SERVICE BULLETIN

N° **139-779**

ATA 21 – ECS SHOCK ABSORBERS REMOVAL RETROMOD

This Service Bulletin is issued in order to provide the necessary instructions on how to perform the ECS shock absorbers removal retromod P/N 3G2150P02411.

Figure 1

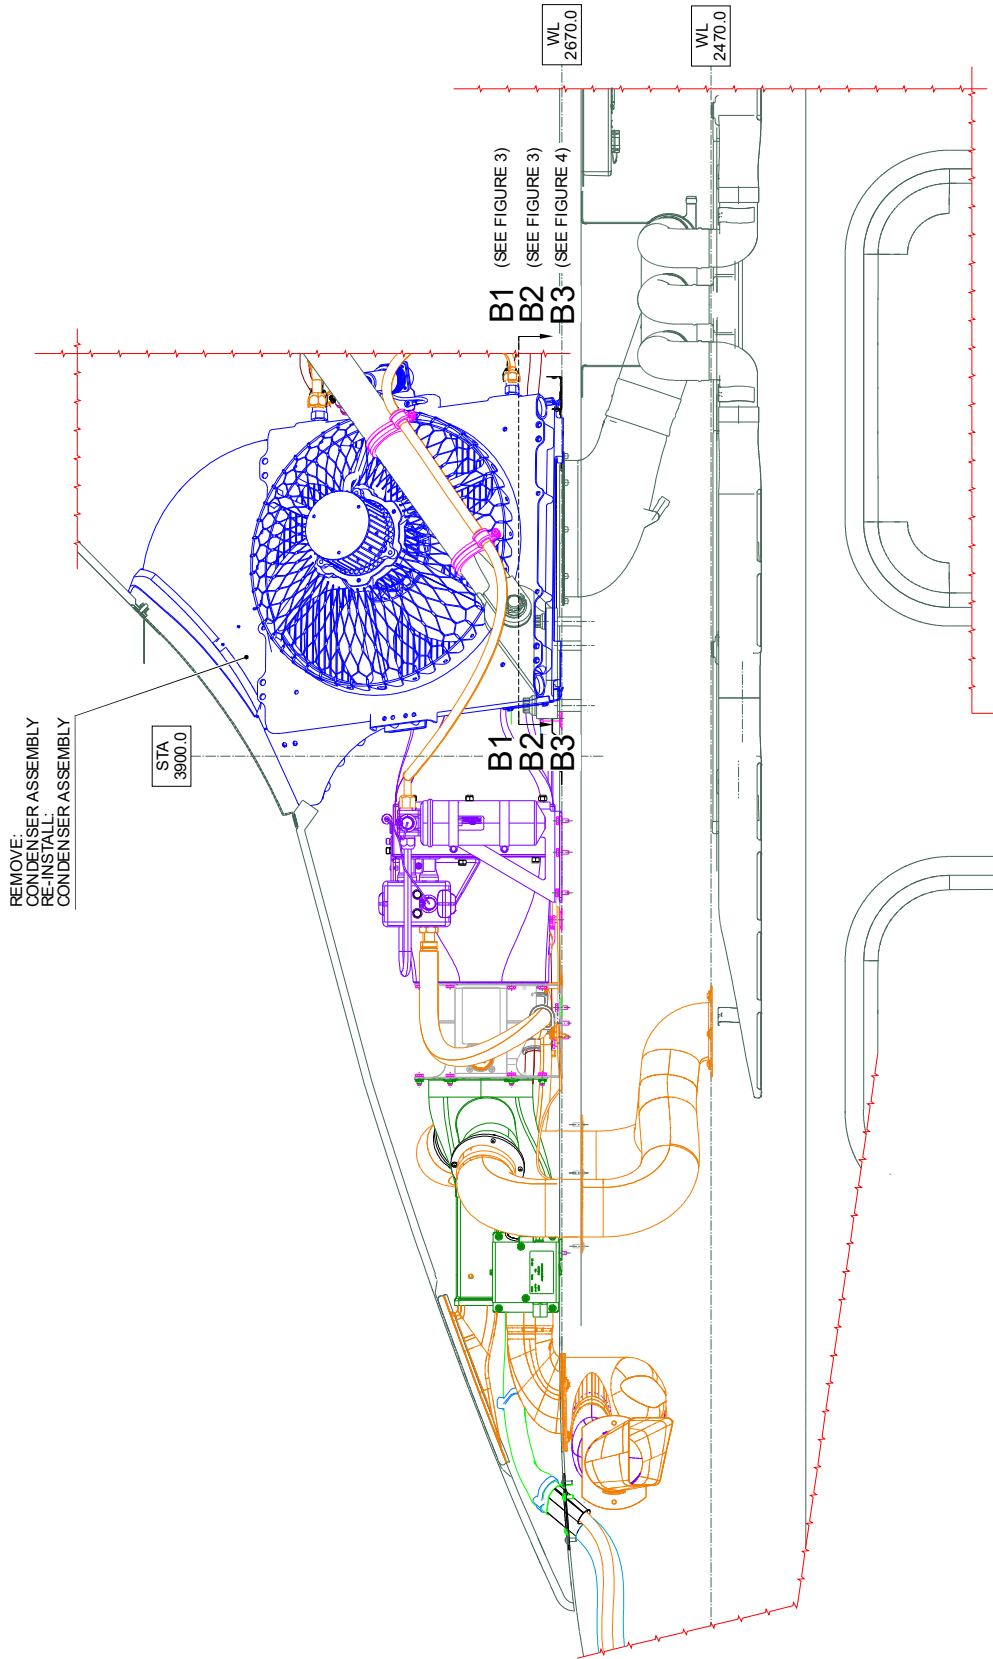
2. In accordance with AMP DM 39-A-06-41-00-00A-010A-A and with reference to Figures 1 thru 4, remove all external panels, internal panels and internal liners as required to gain access to the area affected by the retromod and perform the ECS shock absorbers removal retromod P/N 3G2150P02411 as described in the following procedure:

Figure 2

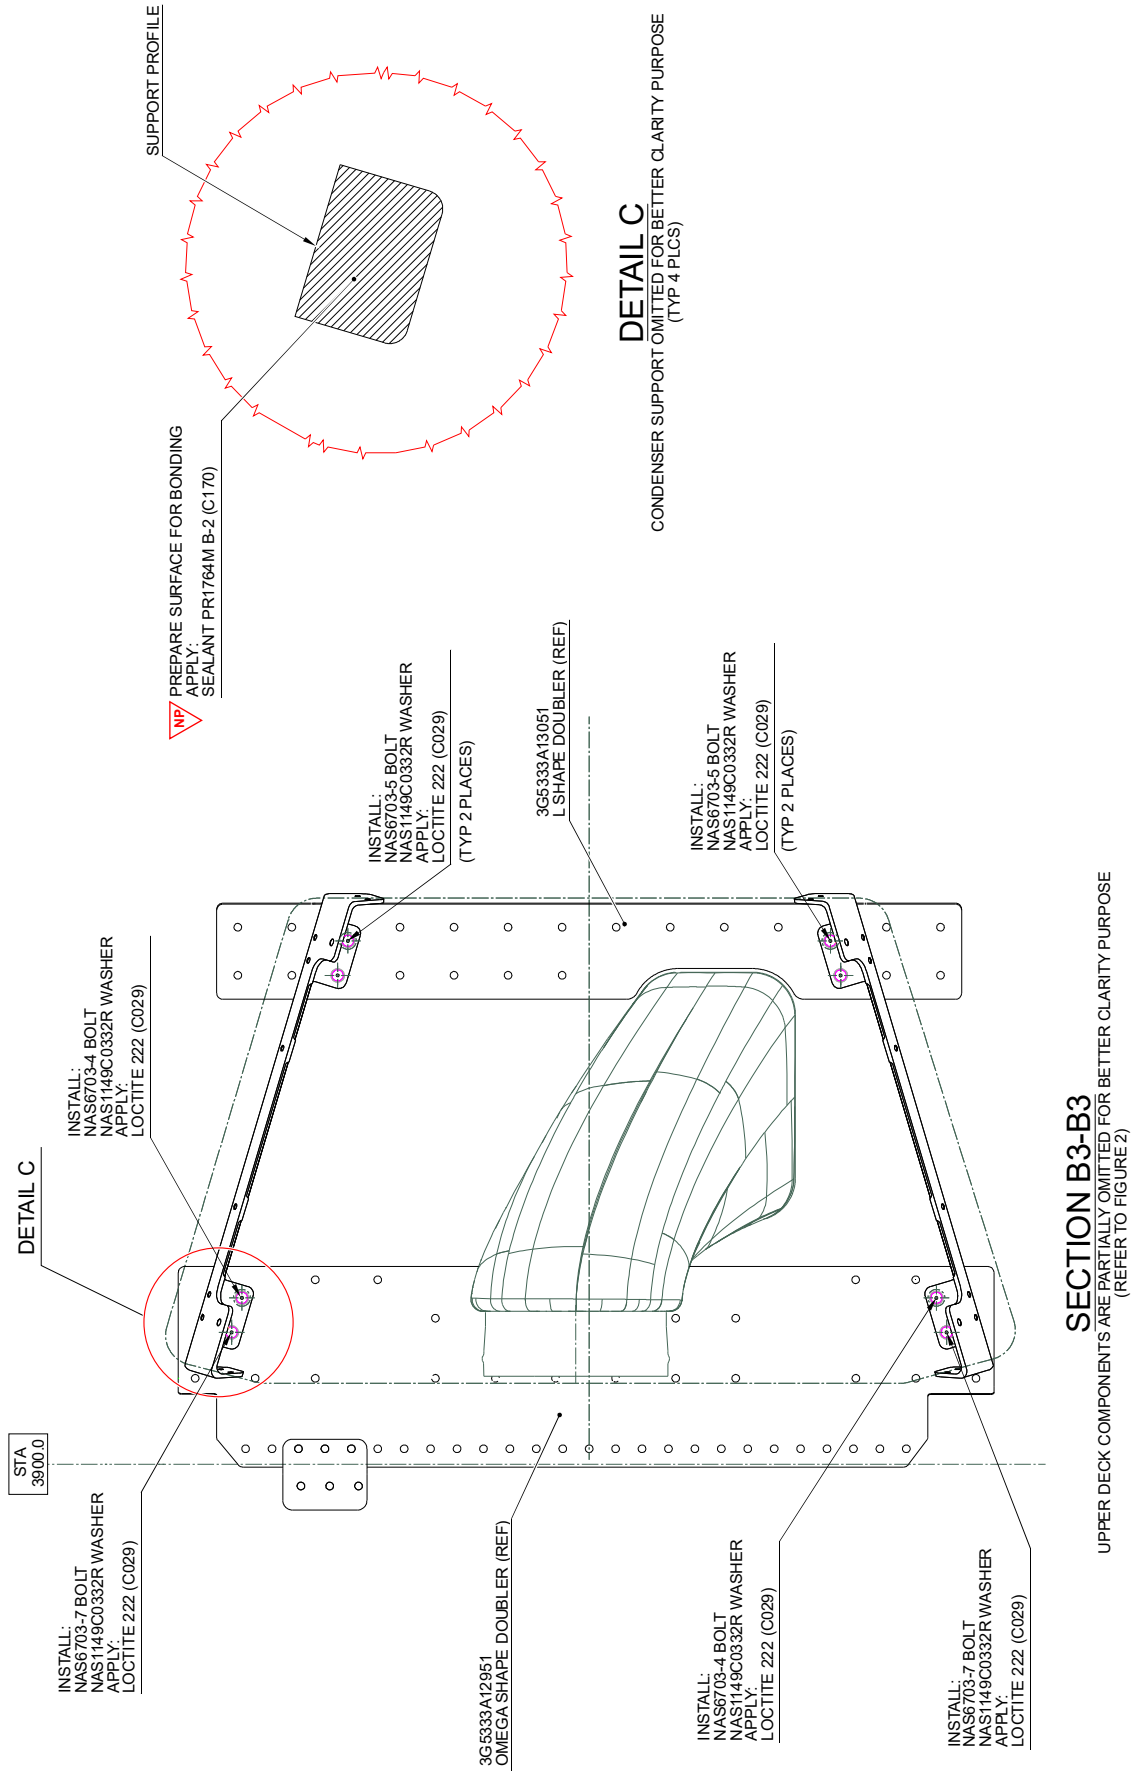
- 2.15 With reference to Figure 2 View A and Figure 4 Section B3-B3, re-install the condenser assembly previously retained by means of n°2 bolts P/N NAS6703-4, n°2 bolts P/N NAS6703-7, n°4 bolts P/N NAS6703-5 and n°8 washers P/N NAS1149C0332R according to the Data Modules listed below as applicable:
- AMP DM 39-D-21-90-03-00A-720A-K;
 - AMP DM 39-E-21-90-03-00A-720A-K;
 - AMP DM 39-F-21-90-07-00A-720A-K;
 - AMP DM39-G-21-90-07-00A-720A-K.
- 2.16 With reference to Figure 4 Section B3-B3, secure connections using loctite 222 (C029).
